**Re: Proposed Rathburn Road Transit Priority Measures Project**

**RE: Rathburn Road Transit Priority Measures Project  
Final Environmental Project Report and Appendices**

**Subject: Rathburn Road Transit Priority Measures EPR**

**Proposal:** Rathbun Road Transit Priority Measures Project  
**Proponent:** City of Mississauga

Qty	Drawing No.	Rev.	Title
4			Revised drawings illustrating the proposed realigned southbound Hurontario Street to Rathburn Road ramp.

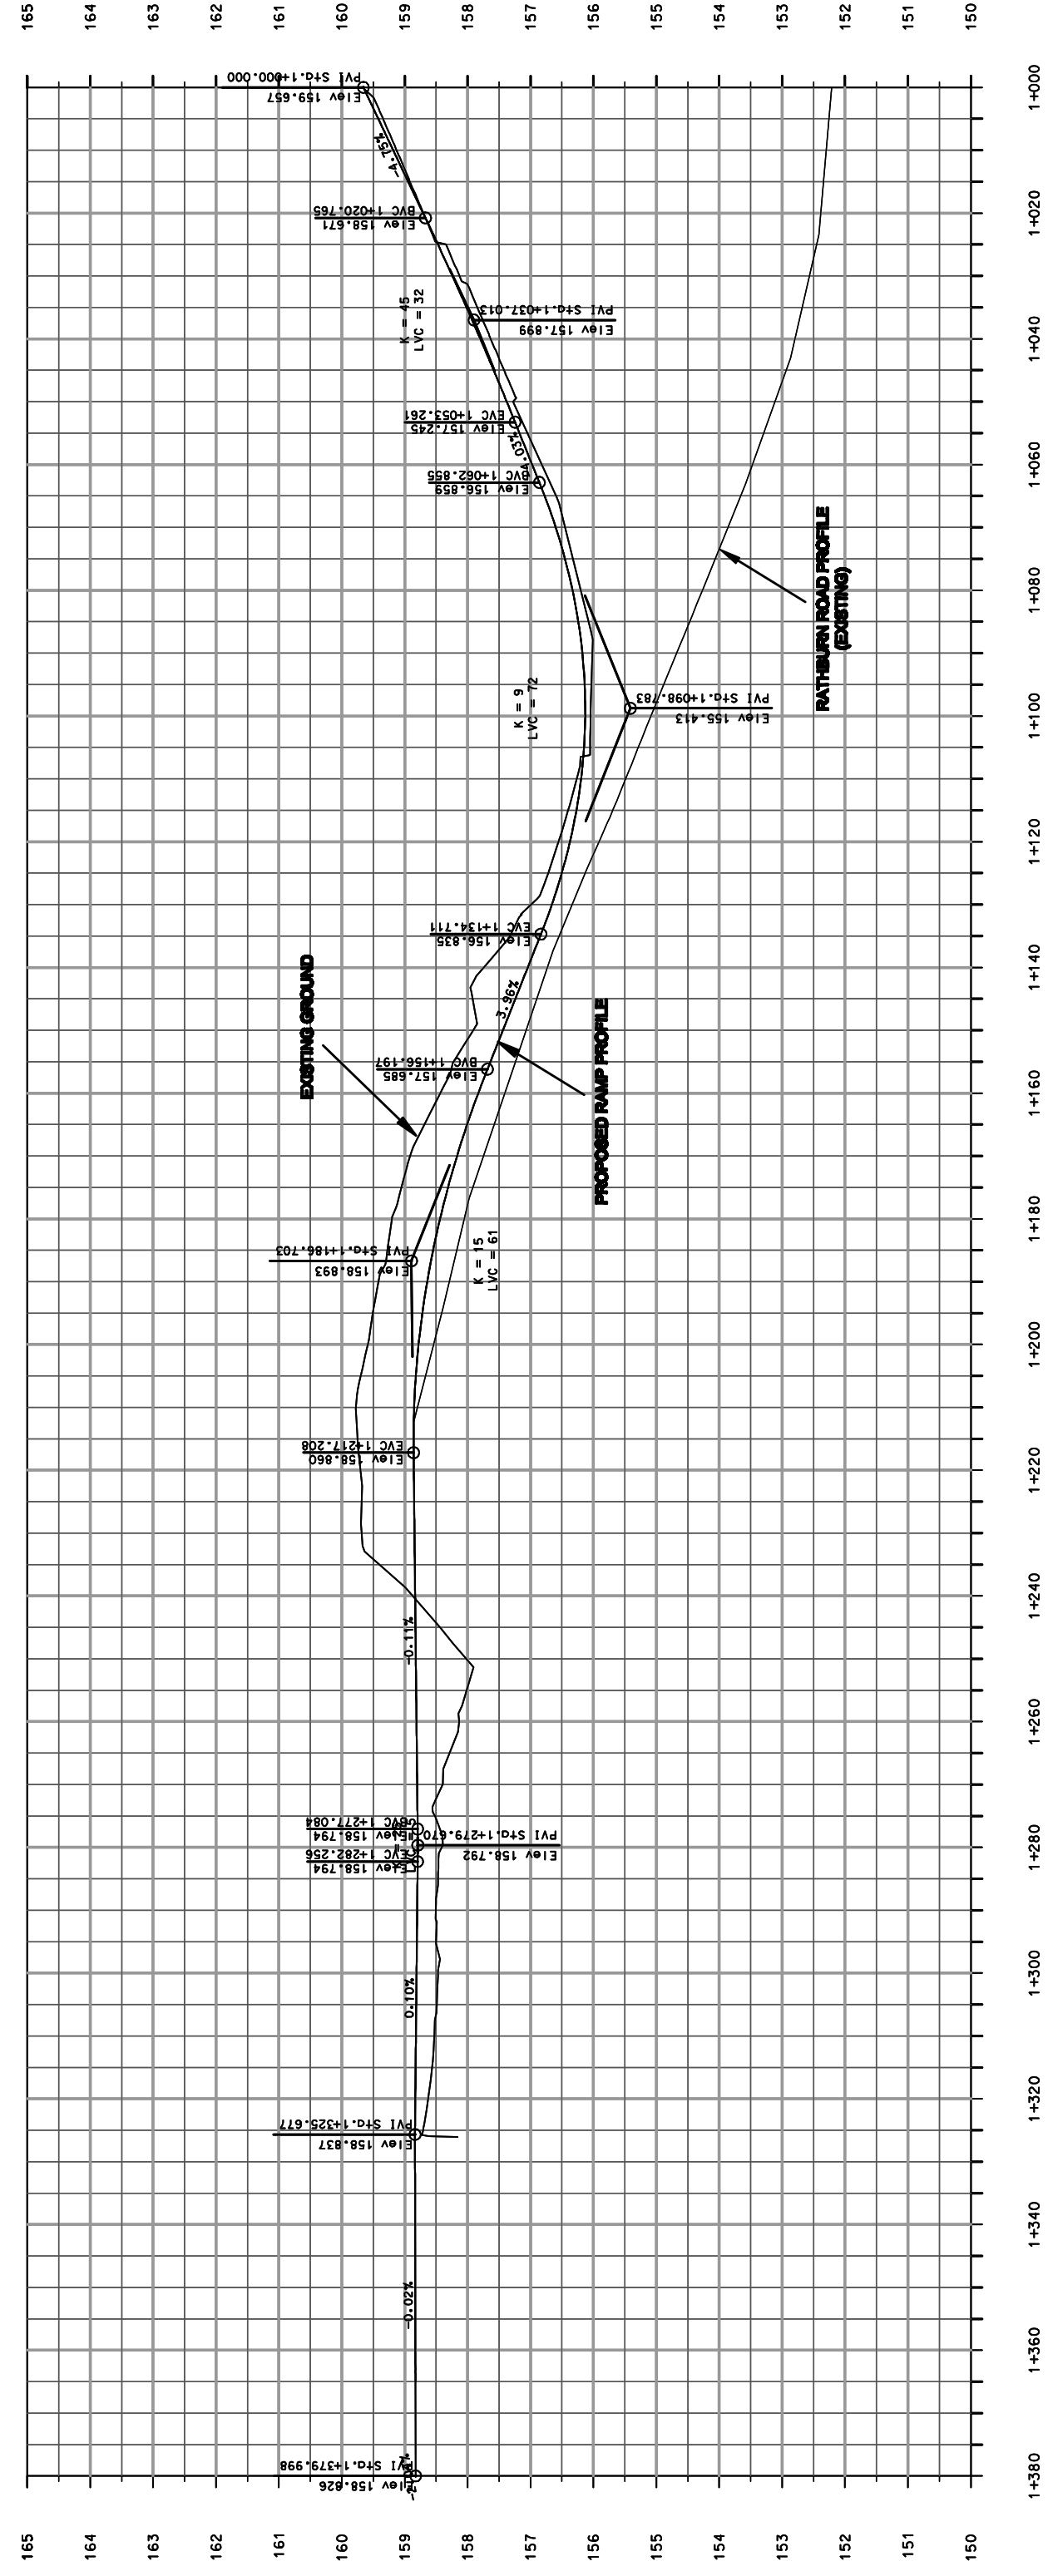
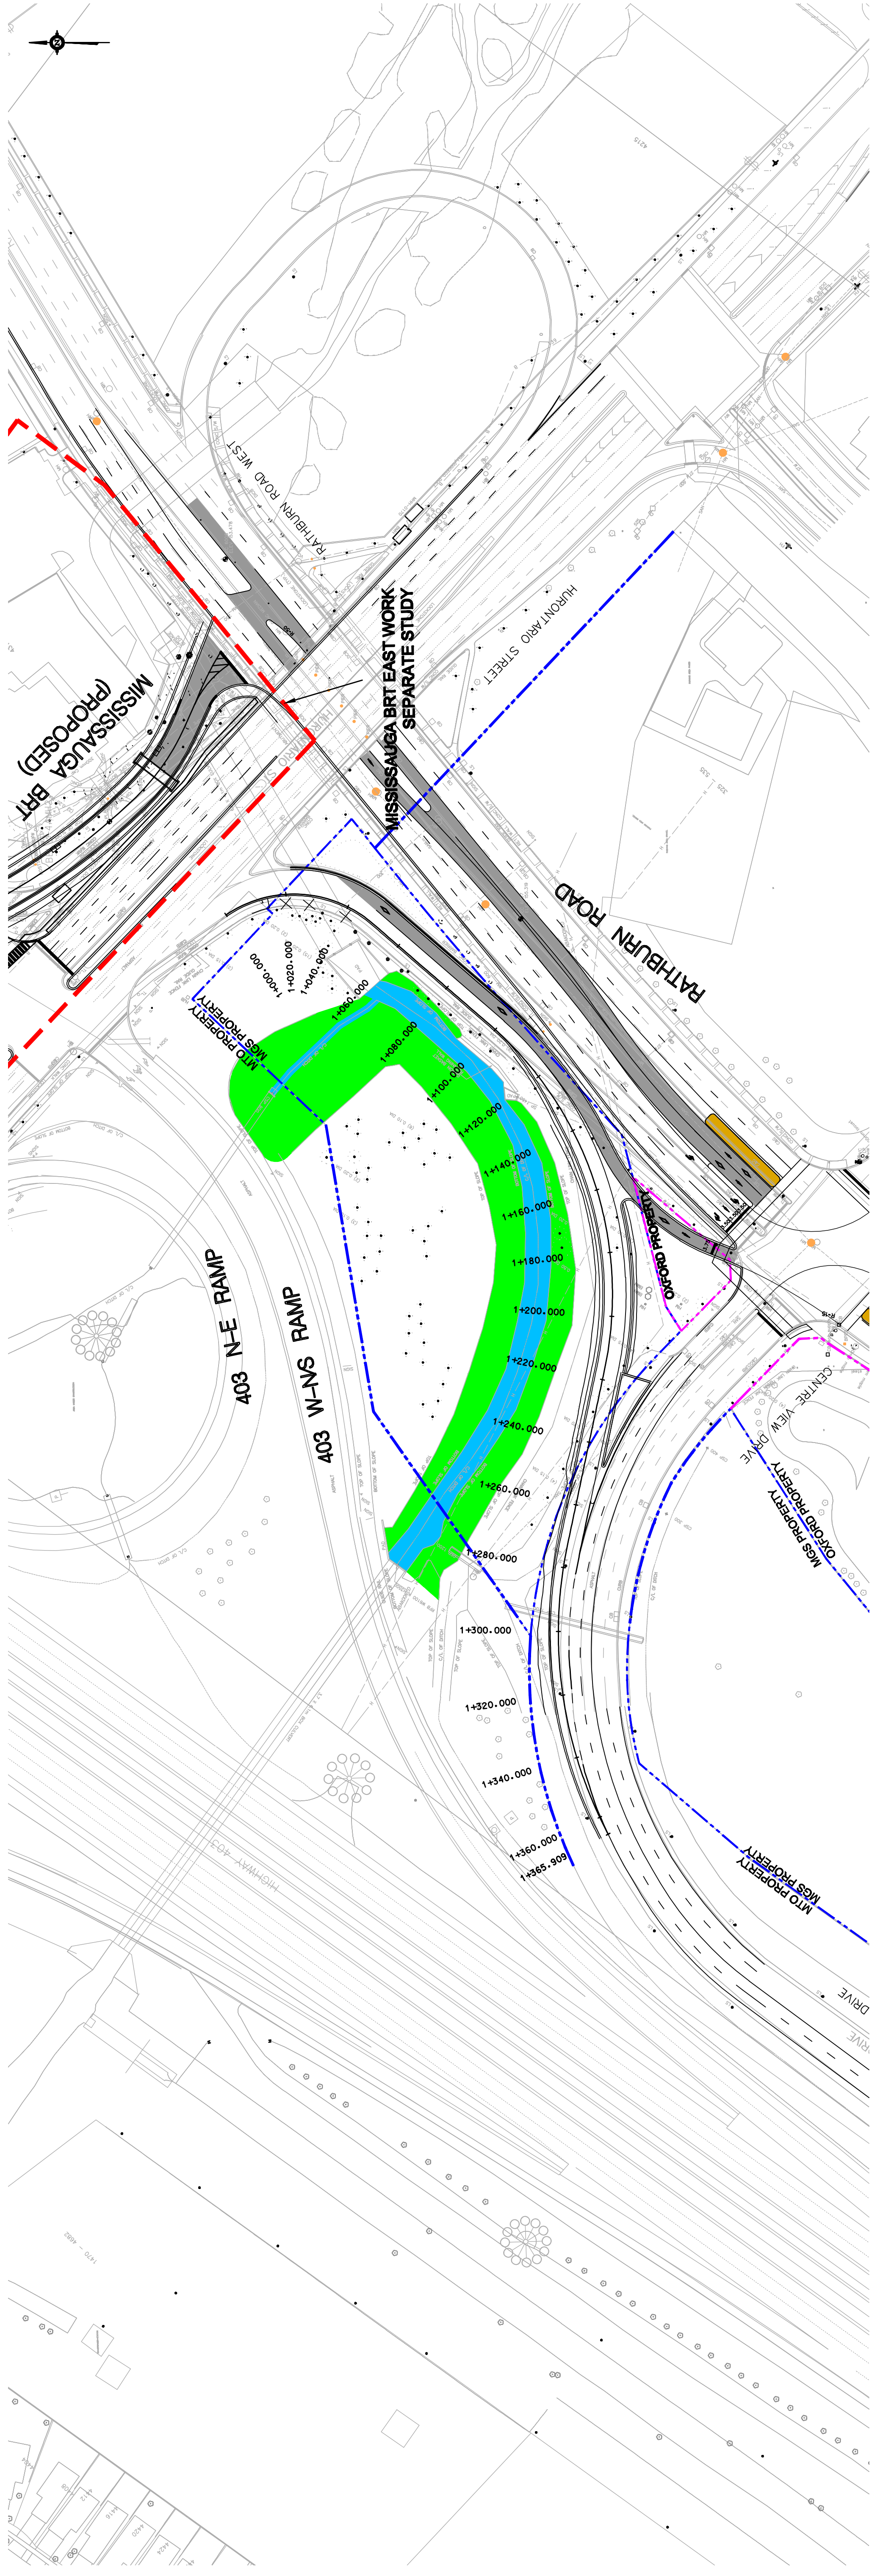
Please note that, while the configuration of the bus-only connection from the ramp to Rathburn Road in the attached plans differs from the previous plan (submitted on December 16<sup>th</sup>, 2009), the ramp profile and alignment remain unchanged.

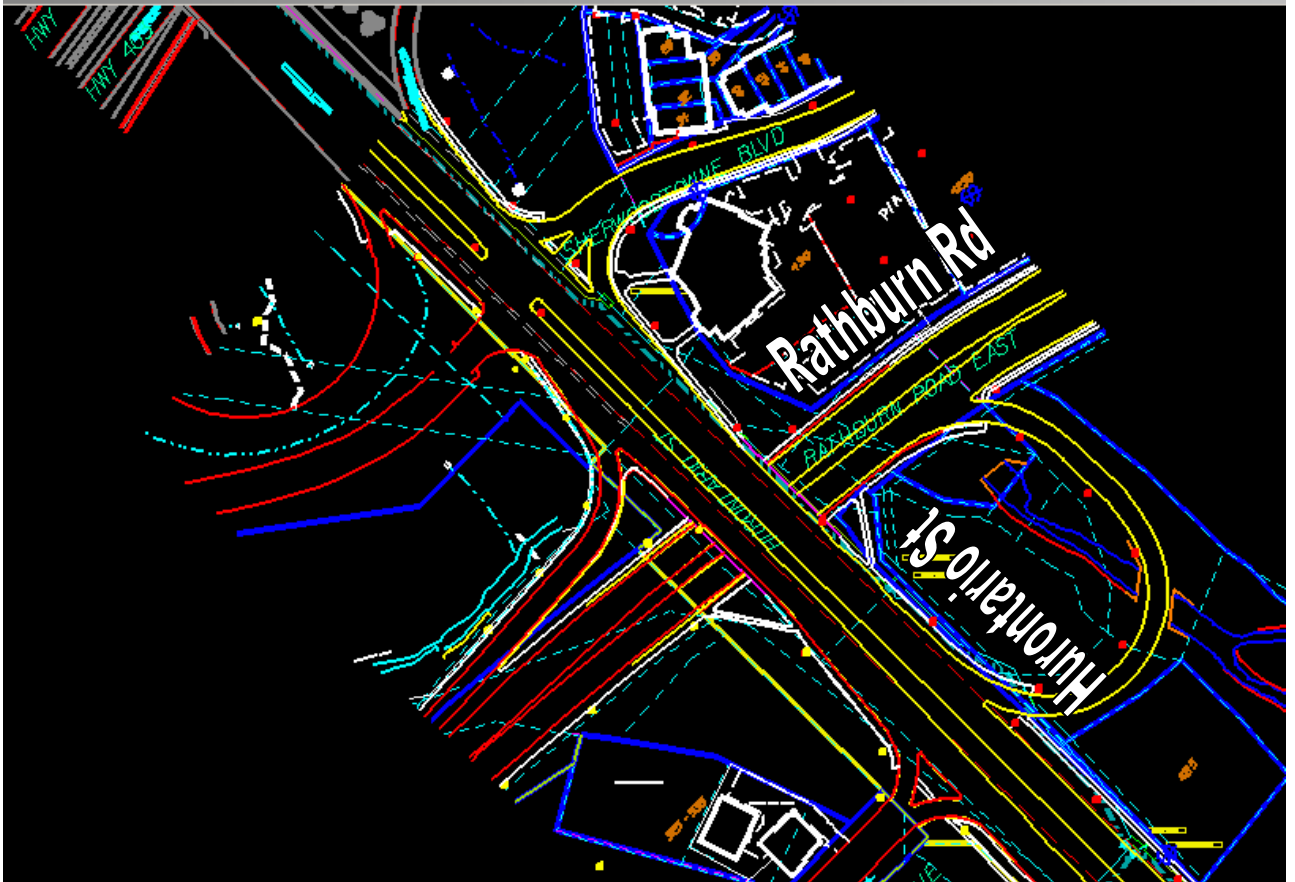
Note: Cogeco Data Services has existing plant along the East side of Hurontario St. Please see the attached picture. Ref# CDS2010-0264
